DRAWING AMENDMENTS

Applic.No. 10/689,671 Amdt. dated 5/3/2006 Reply to Office action of 9/15/05 Annotated Sheet Showing Changes

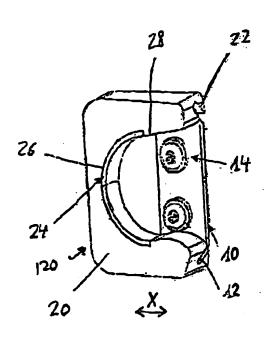
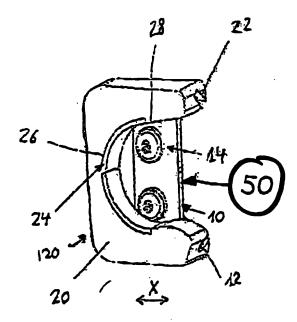
In "Drawings", item 1 on pages 2-3 of the above-identified Office Action, the Examiner objected to the drawings as not showing the ratchet means of claim 8.

In fact, the ratchets have always been shown in the drawings, but without a reference numeral, and claim 8 and paragraphs 0021 and 0022 have always described the ratchets. More specifically, claim 8 originally called for the first base plate 30 having a ratchet and paragraph 0022 of the Specification of the instant application called for the second base plate 10 having a ratchet.

The attached sheet of drawings includes changes to Figs. 1 and 2B, i.e. reference numeral 50 was added to indicate the ratchet. This sheet, which also includes Figs. 2A and 3, replaces the amended drawing sheet submitted on June 20, 2005.

Reference numeral 50 has accordingly been added to Figs. 1 and 2B. The Specification of the instant application has been amended to add reference numeral 50 thereto. As stated
